APPLICANT: Consumers Power Company  
FACILITY: Midland Plant, Units 1 and 2  
SUBJECT: SUMMARY OF MEETING HELD WITH CONSUMERS POWER ON  
GEOLOGY - DECEMBER 2, 1982

SUBJECT: REQUEST FOR ADDITIONAL INFORMATION REGARDING PLANT FILL

ADDITIONAL REQUESTS REGARDING PLANT FILL

CROSS SECTION E-E' and F-F'  
 WESTON GEOPHYSICAL CORP  
 FIGURE 15

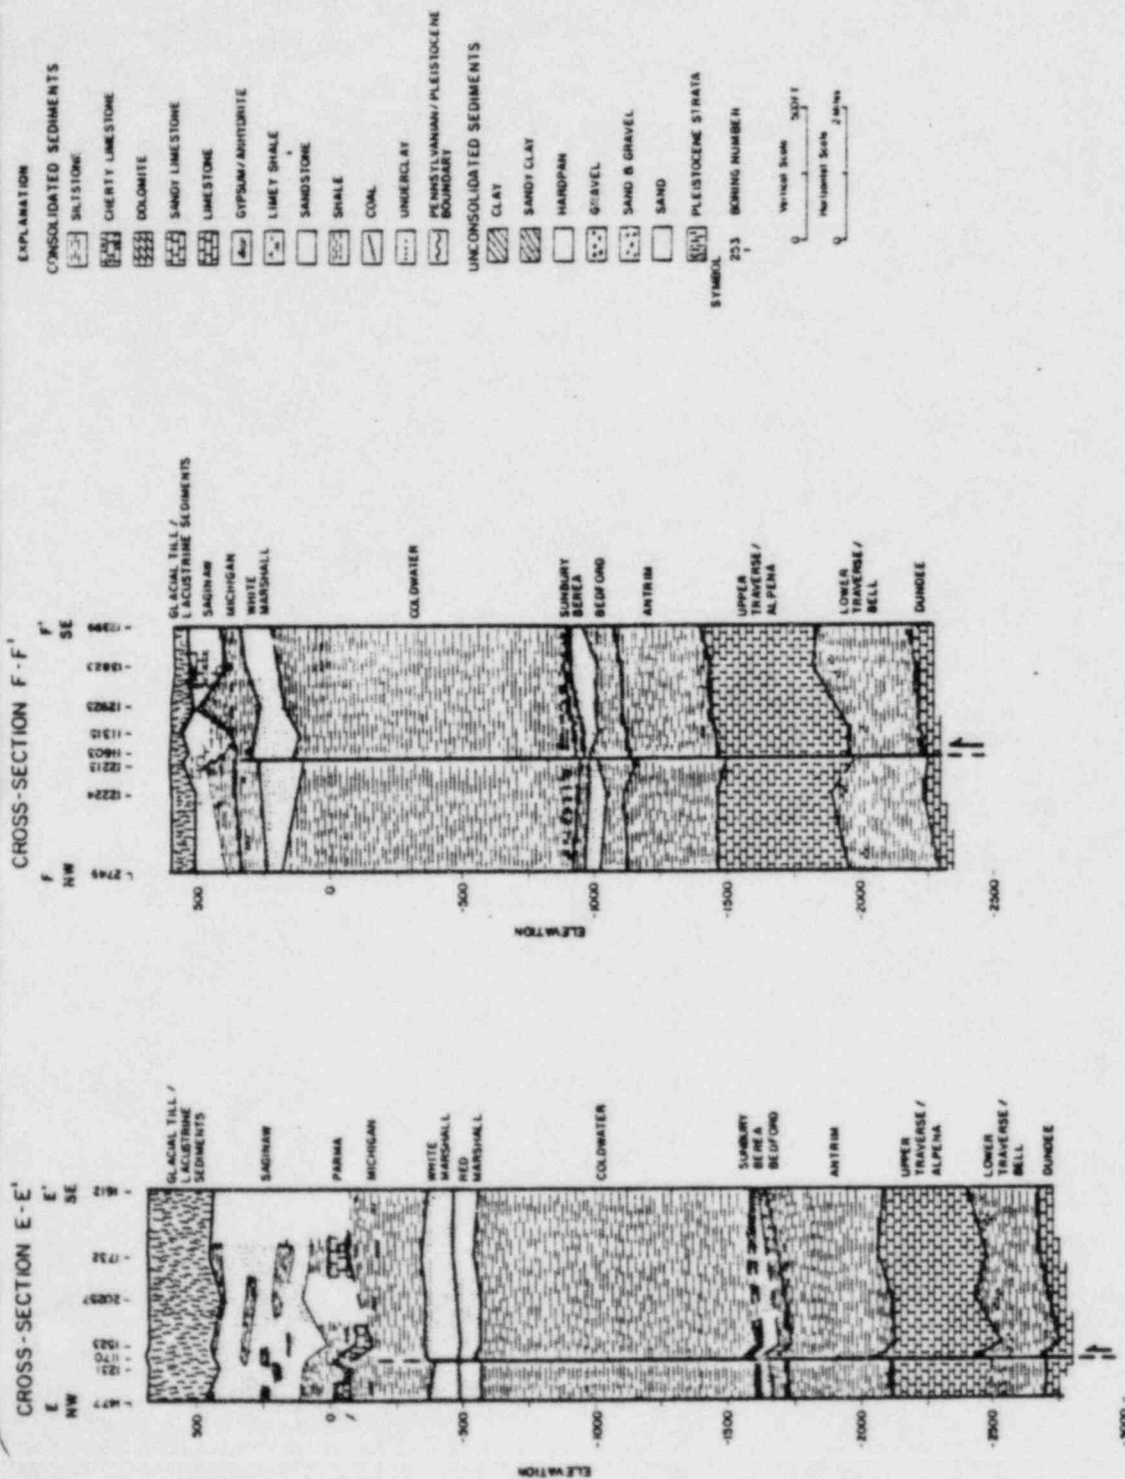
- 2) In cross-section E-E' (Figure 15), which traverses the southeast corner of Porter township, 12 miles southwest of the plant site, a vertical fault is interpreted as extending from below the top of the Dundee Formation upwards into the Michigan Formation. Give a reason to why this fault could not be interpreted as extending vertically upward to cause the observed flexure in the Bayport limestone (labeled Parma sandstone) and the offset of the thin shale unit within the Pennsylvania Saginaw Formation.

Figure 37-2

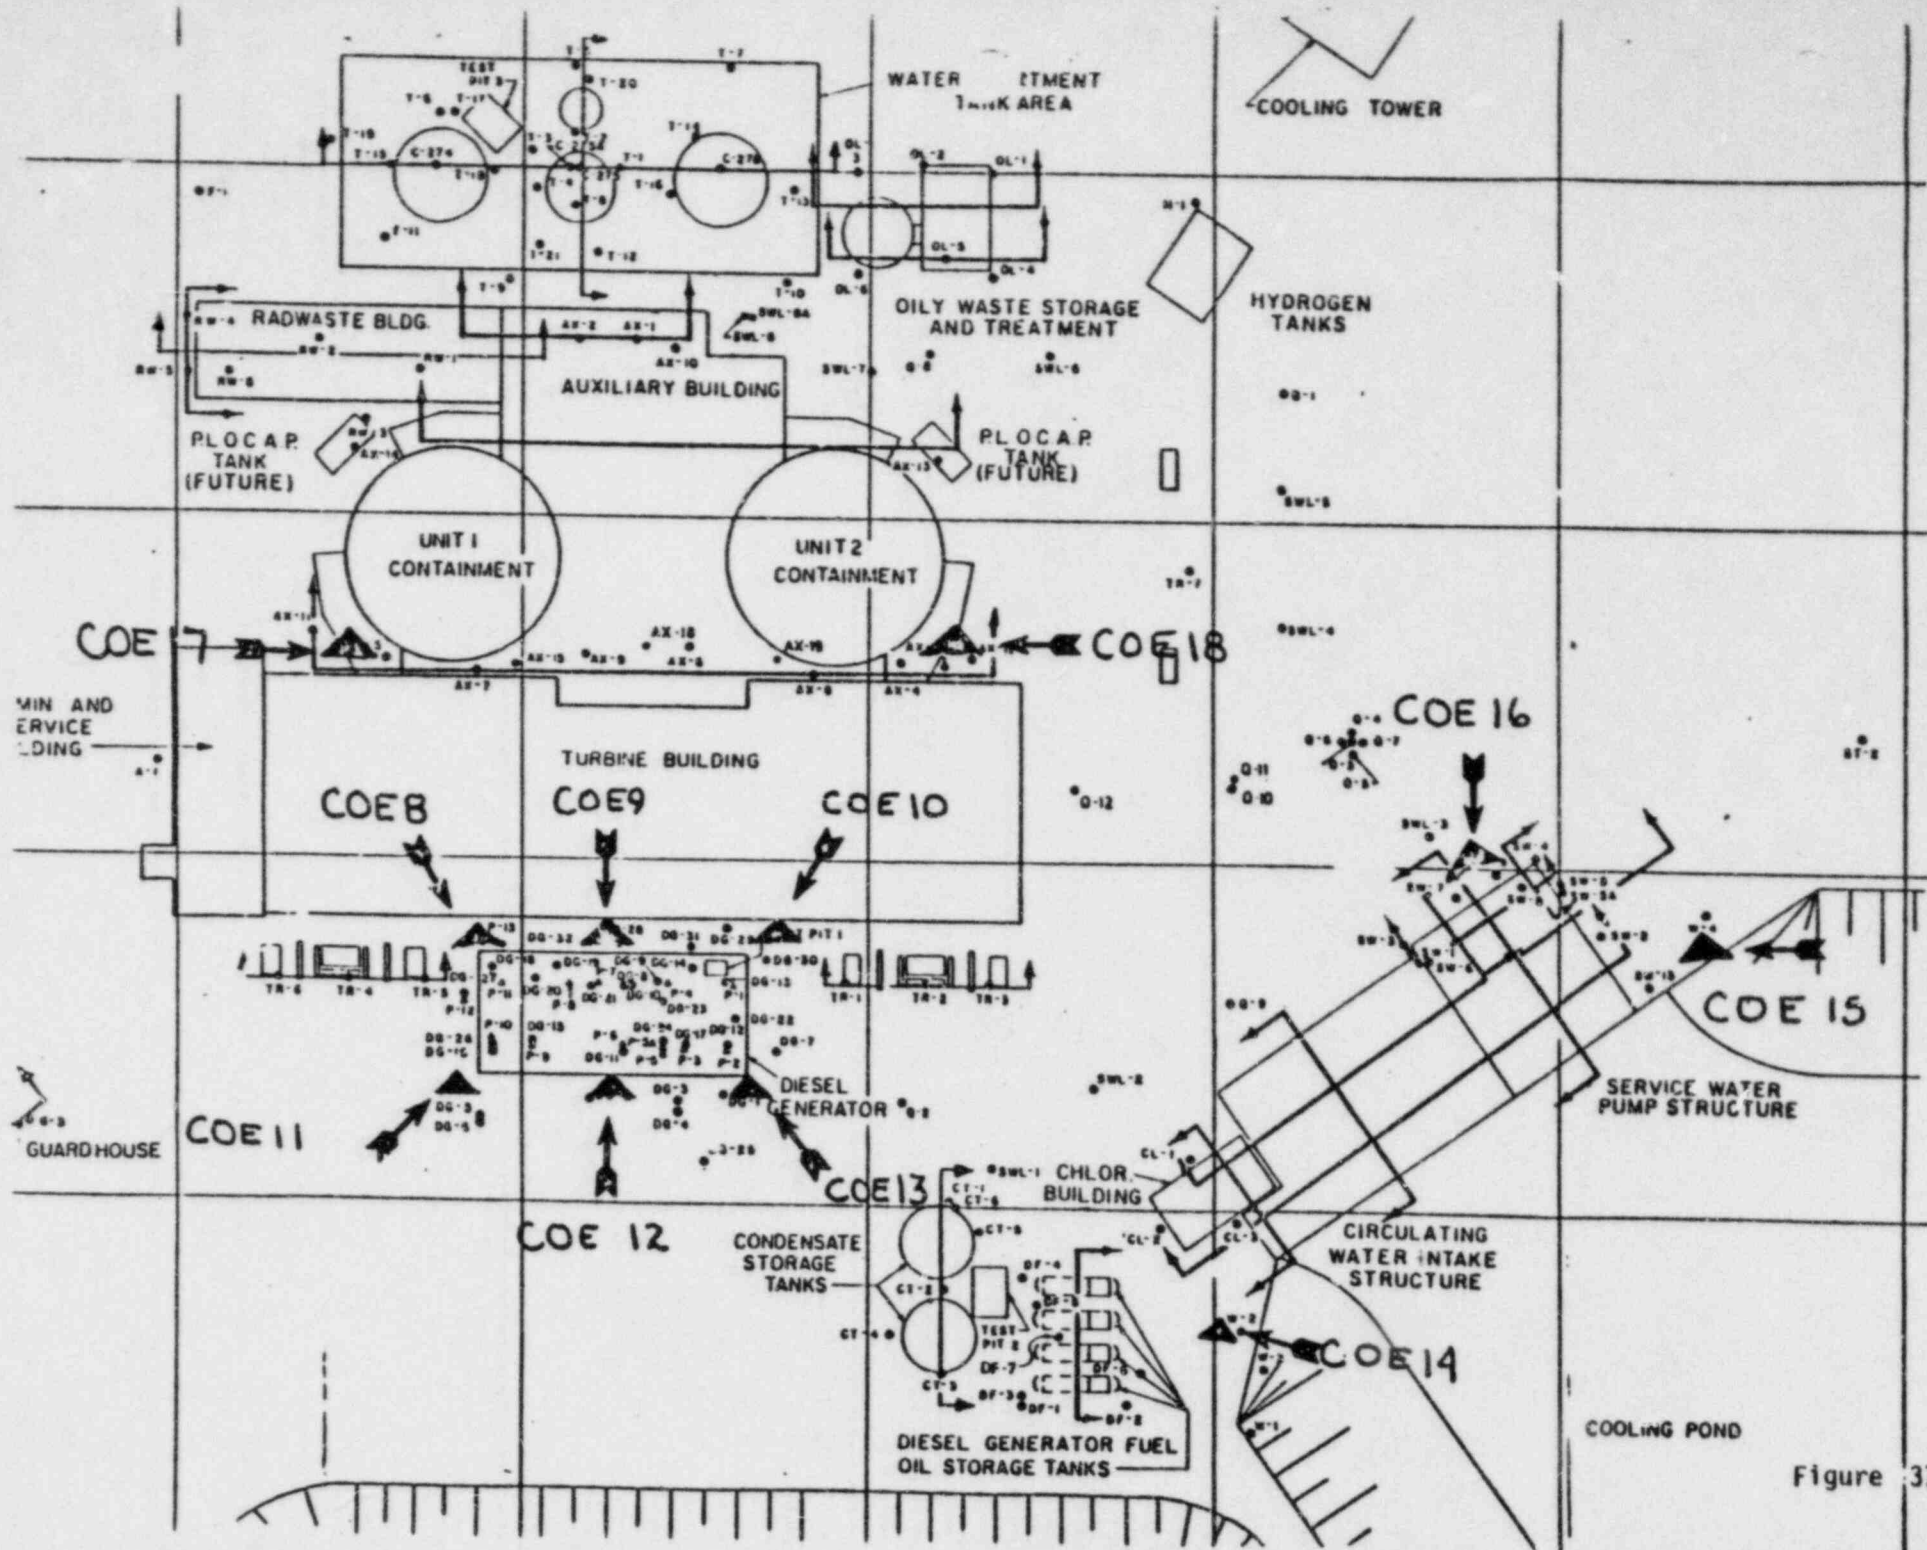
37. (RSP) Your position in previous responses to Requests 5 and 35 not to complete additional explorations, sampling and laboratory testing following the preload program continues to be unacceptable. We require that you complete as a minimum, the exploration and testing program indicated by Table 37-1.

- 1/ See attached Figs. 37-1 and 37-2 for approximate boring location. Holes to be accurately located in the field to avoid obstructions, underground piping and conduits and slurry trench area.
